82540EP Gigabit Ethernet Controller Specification Update

October 10, 2005

82540EP GIGABIT ETHERNET CONTROLLER SPECIFICATION UPDATE

1. 1.5V Regulator Control Circuit

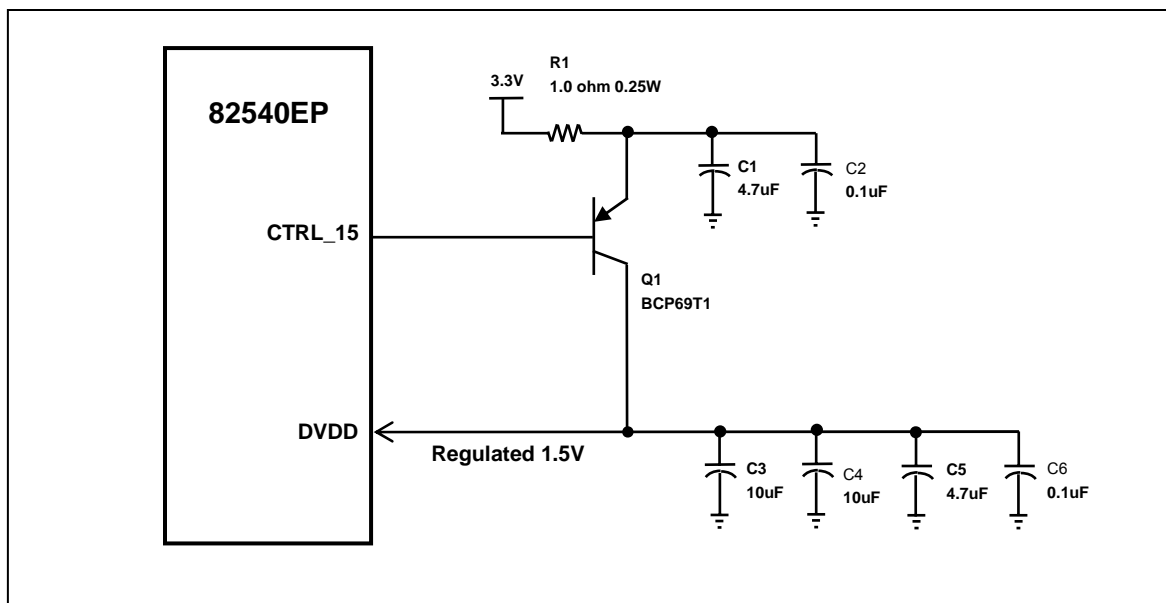
Problem: The 82540EP product contains on-chip LDO voltage regulation controllers for both 1.5V and 2.5V. The 1.5V regulator control output is Ball P11 on the 82540EP controller, and may be optionally used to drive an external PNP pass transistor as shown in the figure below.

The earlier 82540EM Gigabit Ethernet Controller contains an erratum which causes the 1.5V regulator control circuit to possibly start up incorrectly. Workarounds involved the use of a resistor attached to the transistor base, replacing the transistor with a similar model carrying tighter gain specifications, enabling the SMBus, and/or adding a second transistor. The 82540EP controller will work properly in a system containing a recommended workaround for the 82540EM device **as long as the workaround is implemented in its entirety**.

The 82540EP controller does not require any additional workaround, however, and may be applied using the circuit below:
